REED ESTATES SUBDIVISION

APPLICATION NUMBER 6 DATE March 17, 2022

REQUEST Subdivision

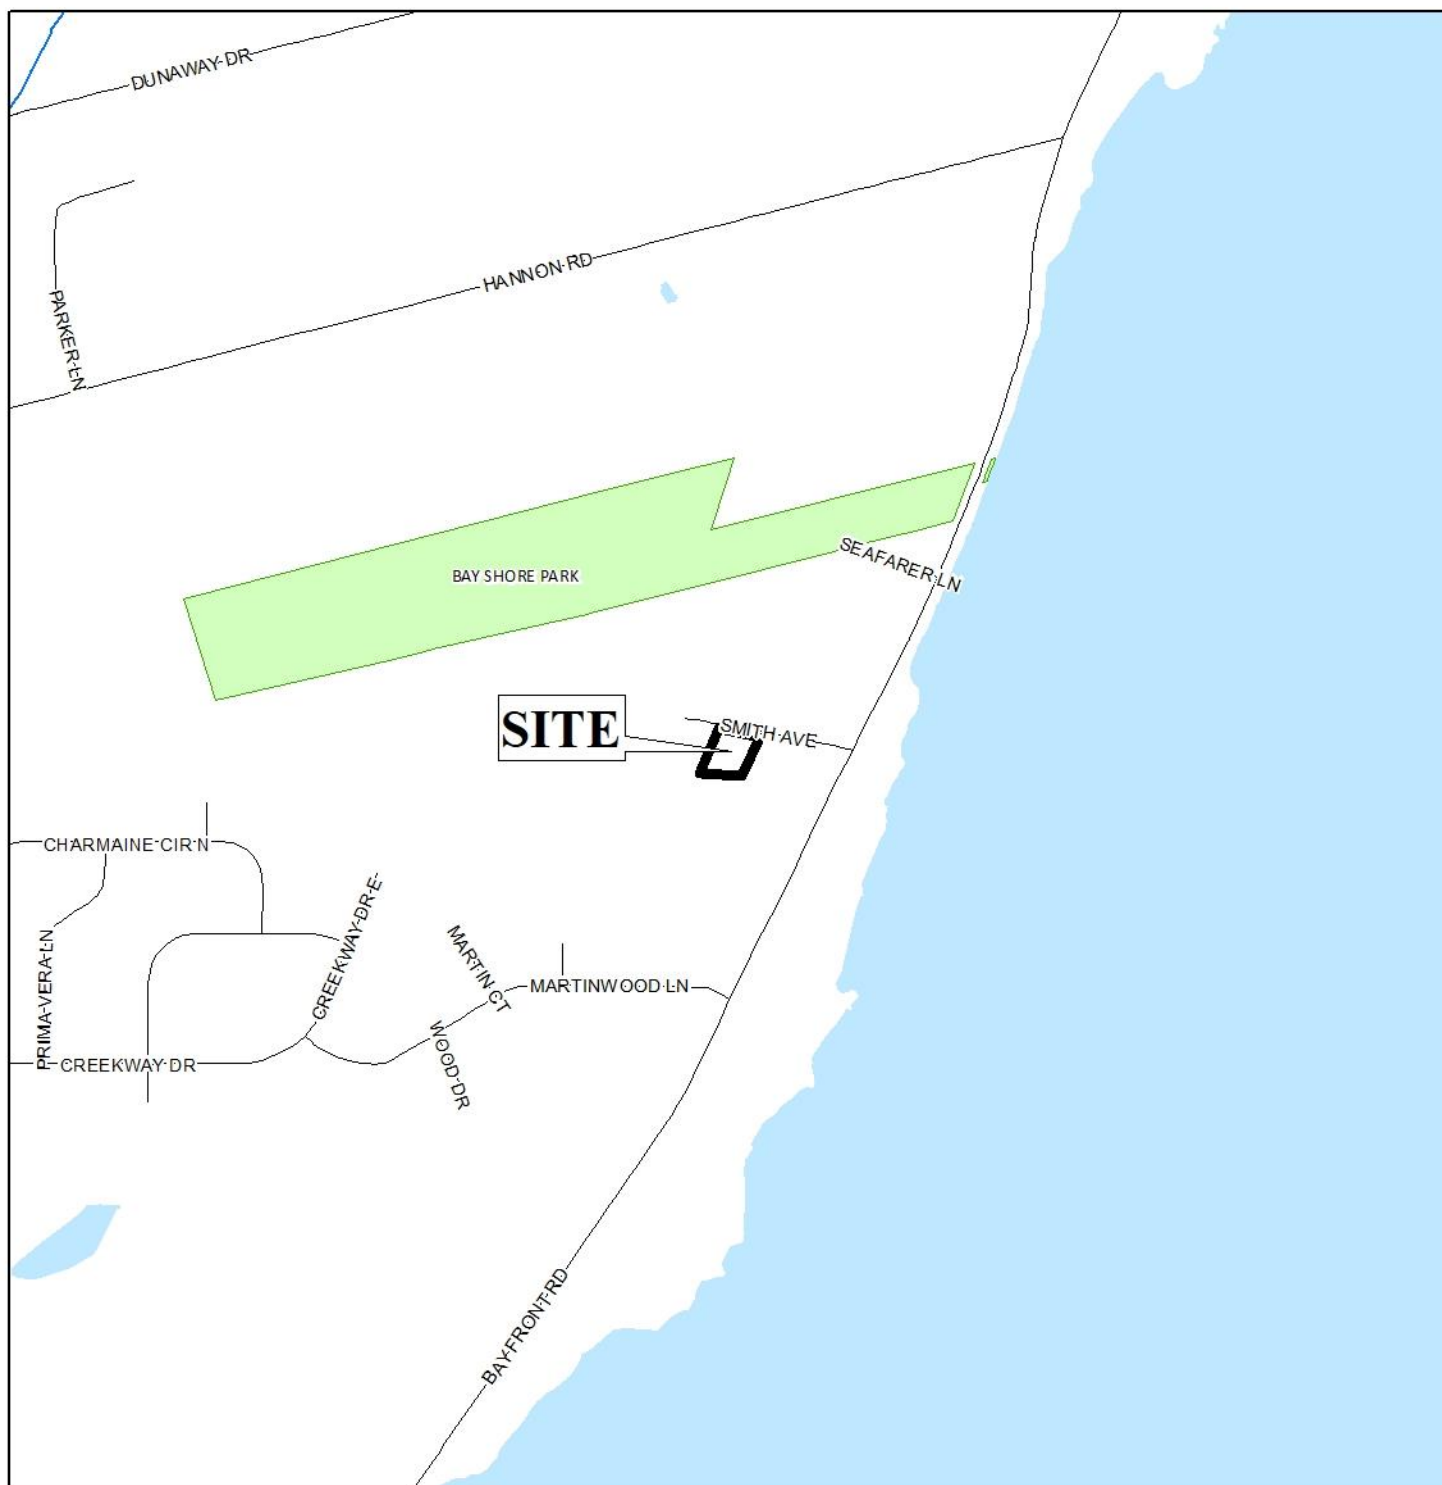
- A. Provide all of the required information on the SUBDIVISION PLAT (i.e. signature blocks, signatures, certification statements, written legal description, required notes, legend, scale, bearings and distances) that is required by the current Alabama State Board of Licensure for Professional Engineers and Land Surveyors.

- B. Add a graphic scale.
- C. Show and label all flood zones. New maps went into effect on June 5, 2020.
- D. Show and label the MFFE (Minimum Finished Floor Elevation) on each lot that contains an AE, V, or X (shaded) flood zone designation.

- E. Add a note to the SUBDIVISION PLAT stating that as shown on the 1984 aerial photo (FLIGHT 29 - #91) LOTS 1 and 2 will receive historical credit of existing (1984) impervious area towards stormwater detention requirement per Mobile City Code, Chapter 17, Storm Water Management and Flood Control) as follows: LOT 1 – 3,050 sf and LOT 2 –NONE.

The proposed lots have frontage along Smith Avenue, a minor street without curb and gutter requiring a 60-foot right-of-way. The existing right-of-way from the centerline of Smith Avenue is 21-feet, which is substandard; however, the original subdivision was platted over 100 years ago, and typically the Planning Commission has only required dedication for newly opened/constructed streets. In this instance, the street is existing and the area is developed; as

such, no additional dedication should be required, and a waiver of Section V.B.14. of the Subdivision Regulations may, therefore, be appropriate.

The proposed lots will exceed the minimum size requirements for lots served by public water and sanitary sewer systems, and they are appropriately labeled with their sizes in both square feet and acres. This information should be retained on the Final Plat, if approved; or provision of a table on the Final Plat with the same information may suffice.

The 25-foot minimum building setback line is illustrated along Smith Avenue, per Section V.D.9. of the Subdivision Regulations, and should be retained on the Final Plat, if approved.

For access management, a note should be placed on the Final Plat, if approved, stating Traffic Engineering comments.

With a waiver of Section V.B.14. the plat meets the minimum requirements of the Subdivision Regulations and is recommended for Tentative Approval, subject to the following conditions:

- 1) Retention of the lot sizes in acres and square feet on the Final Plat, or provision of a table on the Final Plat providing the same information;
- 2) Retention of the 25-foot minimum building setback line along Smith Avenue, in compliance with Section V.D.9. of the Subdivision Regulations;
